Subject: MHI's Responses to US-APWR DCD RAI No. 132-1538 Revision 1

Responses to Request for Additional Information
No. 132-1538 Revision 1

**US-APWR Design Certification
Mitsubishi Heavy Industries, Ltd.
Docket No. 52-021**

RAI NO.: NO. 132-1538 REVISION 1
SRP SECTION: 9.1.2 – New and Spent Fuel Storage
APPLICATION SECTION: 9.1.2
DATE OF RAI ISSUE: 12/18/2008

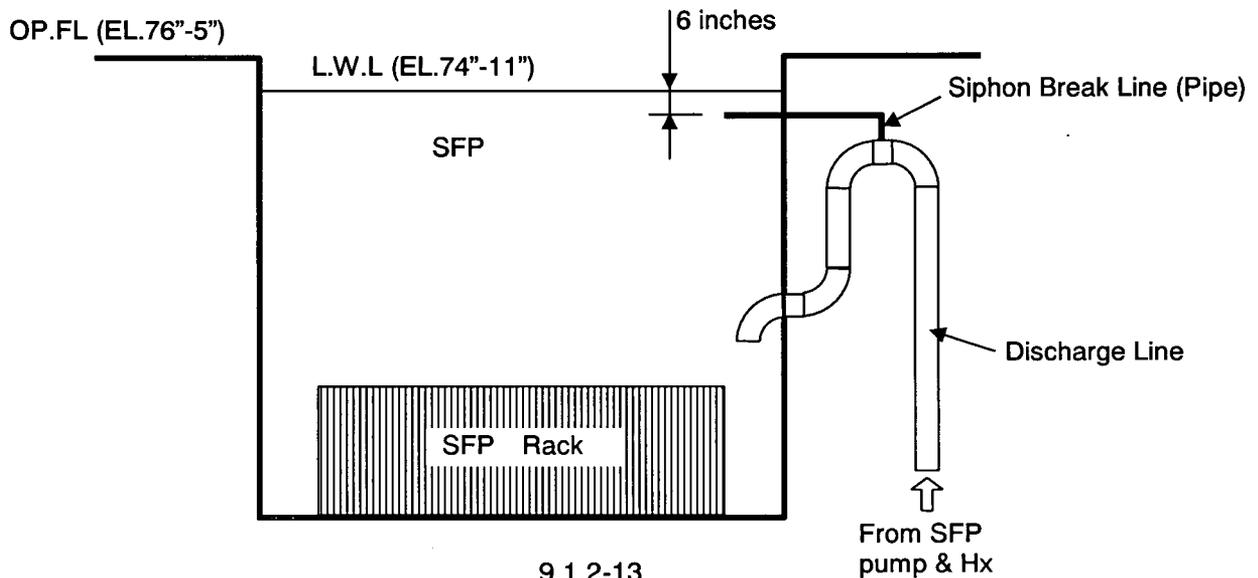
[9.1.2-8] The applicant stated that the pipes that discharge into the SFP are designed with anti-siphon devices to prevent the unanticipated draining of the SFP. This design feature is consistent with the recommendations of SRP Section 9.1.2. The staff also determined that the applicant has not proposed an ITAAC to verify the proper construction and operation of the anti-siphon devices.

The staff requests the applicant to create an ITAAC to verify the proper construction and operation of the anti-siphon devices.

The sketch below illustrates the intended SFP Siphon Breaker Line design. Its operation depends only on water level dropping to the level of the line opening and therefore does not have a specific ITAAC item associated with it. MHI will add the anti-siphon feature to the Tier 1 Figure 2.7.6.3-1 Spent Fuel Pit Cooling and Purification System. Verification of the existence of the siphon breaker line will be performed to satisfy the functional arrangement ITAAC, item #1 in Tier 1 Table 2.7.6.3-5. To remove any confusion, the Note 1 on DCD Figure 9.1.3-1 will be clarified.

DCD Revision 1 Tier 1 Figure 2.7.6.3-1 Spent Fuel Pit Cooling and Purification System will be revised to identify the siphon breaker line.

Tier 2 DCD Figure 9.1.3-1, Note 1 will be revised as follows:

"1. RELEASE LOCATE THE SIPHON ~~BLEAKER~~ BREAKER LINE (PIPE) ABOUT 6 INCHES BELOW NORMAL LOW WATER LEVEL."
